HIOKI 8855 Firmware and optional 9549 Software Defect Details

1. Erroneous current measurement with the Hioki 8855 and 9279, and PC application enhancements

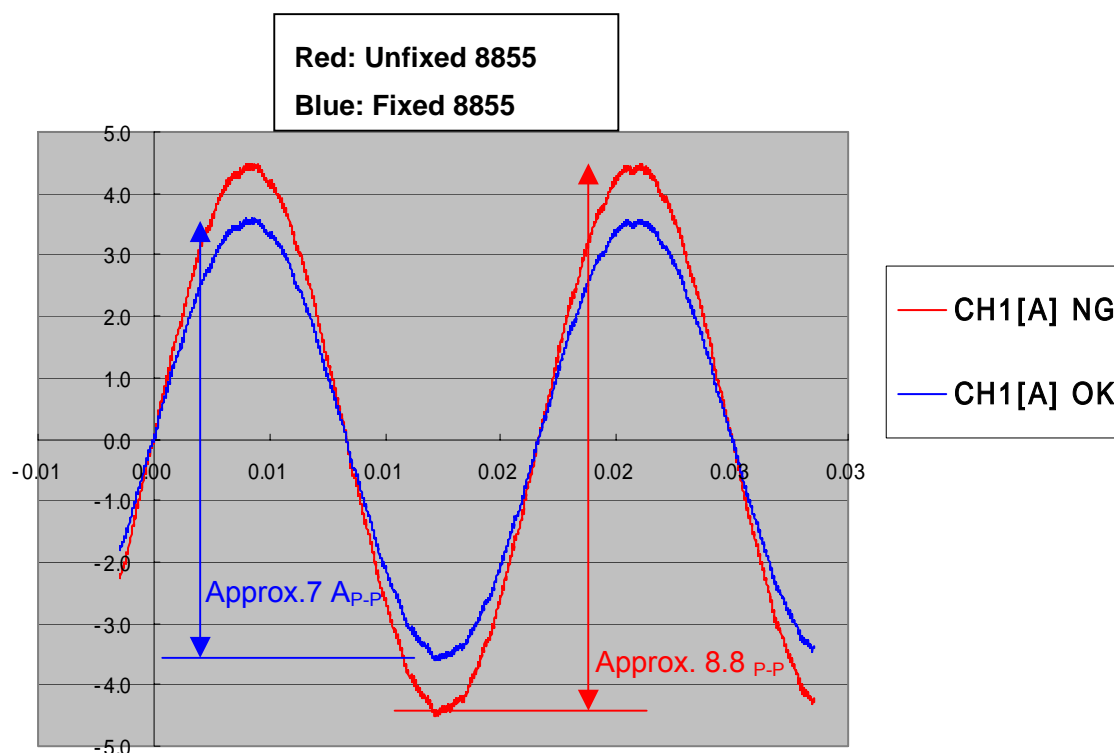
- When measuring current with **the combination of Model 8951 Voltage and Current Unit and the 9279 Current Probe**, after acquired waveform data has been saved as a binary format file, data values will be 1.25 times larger than their initially measured values when the file is subsequently loaded by the Model 9335 Waveform Processor or the WV Wave Viewer. The measurement ranges producing erroneous values are **500 mA/div, 1 A/div, 10 A/div and 20 A/div**.
- As a result, if the waveform data file is converted to CSV format by the Hioki 9335 or WV software application and displayed graphically in Excel, its amplitude will be 1.25 times the measured level.
- However, the waveform displayed on the 8855 is unaffected.

500 mA/div range: with 2.5 A (rms) input data converted to CSV format and displayed in Excel

→ Measured values of about 7 A_{P-P} are erroneously displayed as about 8.8 A_{P-P}.

Improved functions of the Hioki 9333, 9335 and WV software applications - Waveform files that were saved before the 8855 was fixed can be read properly by calculating a new conversion factor using the 8855 range information and according to whether or not the Model 9279 was used, without using the conversion factor saved with the (binary format) waveform files.

Defect Example:

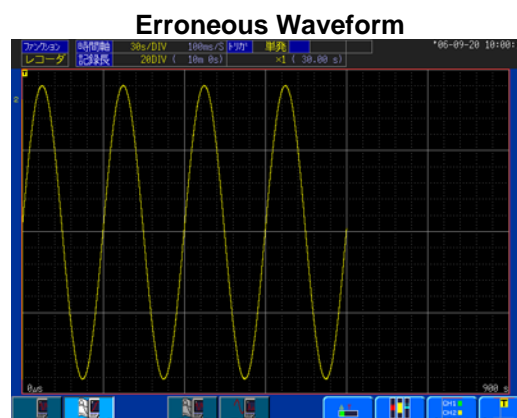
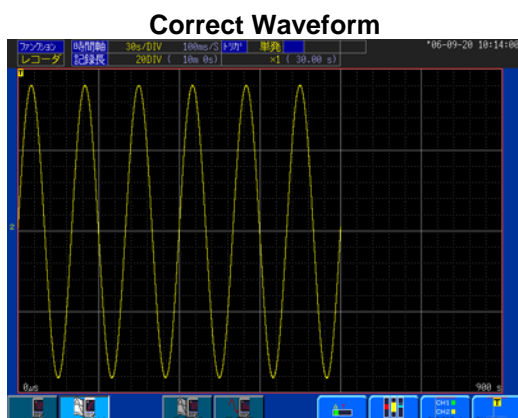
- Depending on the combination of the timebase and sampling settings, actual recording length may be shorter than the set time. Particularly when the timebase is set to 30 s/div, actual recording occurs at 20 s/div, so the time axis is erroneously lengthened and recording time is only 2/3 of the correct length.

With the instrument timebase set to 30 s/div, monitoring a sine wave with a 100-second period for 20 divisions should capture six cycles of the waveform. However, because of the defect, only four cycles are captured, as the actual timebase is 20 s/div.

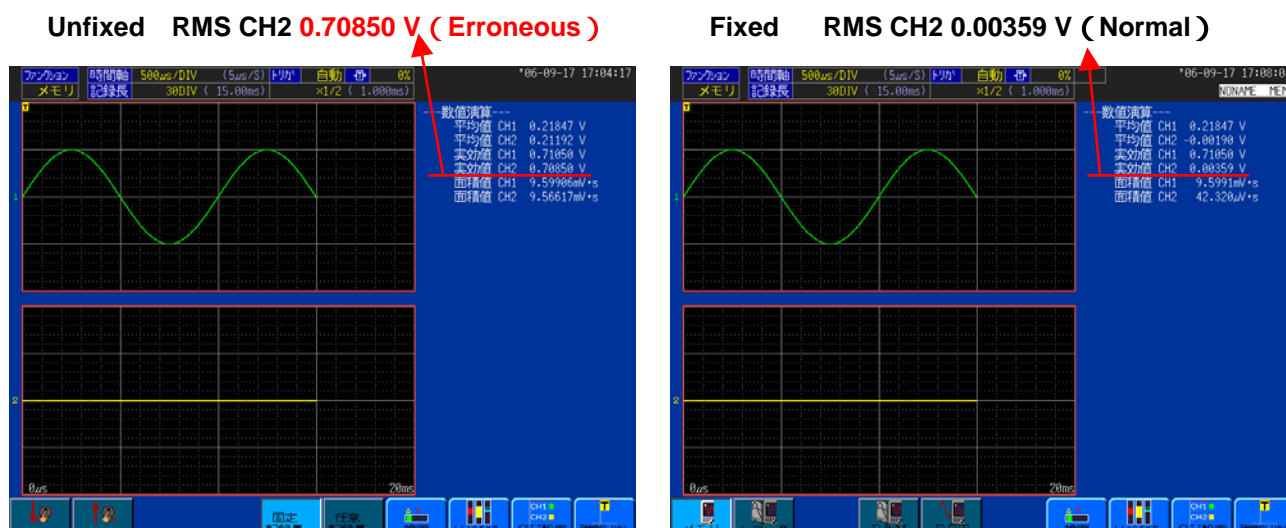
- When performing numerical calculation on lower-numbered channels using the Memory function, calculation results for Average, RMS and Area values on channels other than CH1 are incorrect (calculated results are completely unrelated to measured values).

Calculation results with the following channels are erroneous:

- CH2 when the Use Channels setting is CH1-2
- CH2, CH3 and CH4 when the Use Channels setting is CH1-4

- In this case, the Use Channels setting is CH1-2, with a 2 Vp-p sine wave applied to CH1 and no signal applied to CH2. Average, RMS and Area values are calculated after measurement.
- Although the calculation results for CH2 should be near zero, before the fix is applied (left figure), they are almost the same as the values for CH1(!). After the fix is applied (right figure), the calculated values for CH2 are near zero. (This is only one example of the defect: the erroneous values are not always near those of CH1.)
